Urgent Product Service Notification

Pressure Switch Tubing Upgrade Program

SL 26-260 G3 & SL 40-399 G3 – Pressure Switch Tubing Upgrade Program

See over for a sample rating plate and serial number.

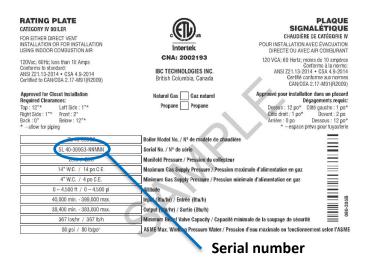
The affected SL 26-260 G3 & SL 40-399 G3-series boilers were produced between April 2017 and March 1st, 2021, and can be identified with the serial number on the rating plate.

The rating plate which includes the model and serial number is located inside the boiler cabinet.
